Access Compliance Report

Public Rights-of-Way

(Curb Ramps)

Intersection ID: 29957	Main Street: PANOS_DR	Cross Street: SMITH_CORNERS_BV	Location: NW
ADA ID: 7A8EB05E8CF3	Ramp Type: BlendTrans1	Initial Pass/Fail: Fail	Overall Compliance: No
		Severity Score: 25

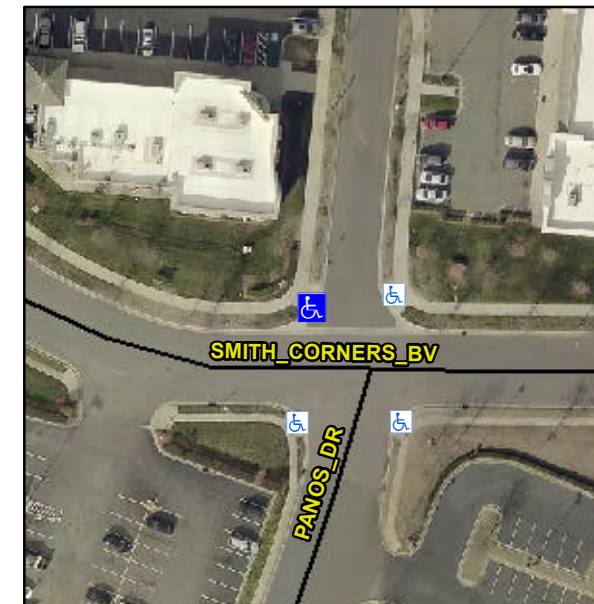
Not Found, R304.5.3

Compliance	Description	Data	Compliance	Description	Data
N/A	Ramp Length (in)	93.0	Yes	BlendTrans Slope (%)	3.6
Yes	Ramp Width (in)	57.0	No	BlendTrans XSlope (%)	7.4
N/A	Flare Type LT	N/A	N/A	Flare Type RT	N/A
N/A	Flare Slope LT (%)	N/A	N/A	Flare Slope RT (%)	N/A
N/A	Flare Traversable LT?	N/A	N/A	Flare Traversable RT?	N/A
N/A	Landing Length (in)	N/A	N/A	DWS Provided?	N/A
N/A	Landing Width (in)	N/A	N/A	DWS Contrast?	N/A
N/A	Landing Slope (%)	N/A	N/A	DWS Length (in)	N/A
N/A	Landing X Slope (%)	N/A	N/A	DWS Full Width?	N/A
N/A	Landing Curb? (Y/N)	N/A	N/A	DWS Offset (in)	N/A
N/A	Shared Landing?	N/A			
N/A	Gutter Ponding?	N/A	N/A	Gutter Slope (%)	N/A
N/A	Gutter Lip Ht (in)	N/A	N/A	Gutter X Slope (%)	N/A
N/A	Painted X Walk1?	No	N/A	Painted X Walk2?	No
	X Walk 1 Direction	To S		X Walk 2 Direction	To E
	X Walk 1 Width (in)	N/A		X Walk 2 Width (in)	N/A
	X Walk 1 Slope (%)	6.0		X Walk 2 Slope (%)	2.8
	X Walk 1 X Slope (%)	1.7		X Walk 2 X Slope (%)	2.6

N/A	Ramp inside XWalk1?	N/A	N/A	Ramp inside XWalk2?	N/A
	Road Slope (%)	2.7		Clear Space?	N/A
	Road X Slope (%)	0.3	N/A	Clear Space to XWalk (in)	N/A
N/A	Any Obstructions?	N/A	N/A	Storm Grate/Utility Hazard?	N/A
	Obstruction Type			Storm Grate/Utility Type	
		N/A			N/A
			Yes	Surface Condition? (G/P)	Good
			No	Curb Slope (%)	10.3

Remove & Replace Curb Ramp With Two New Directional Ramps or Equivalent.
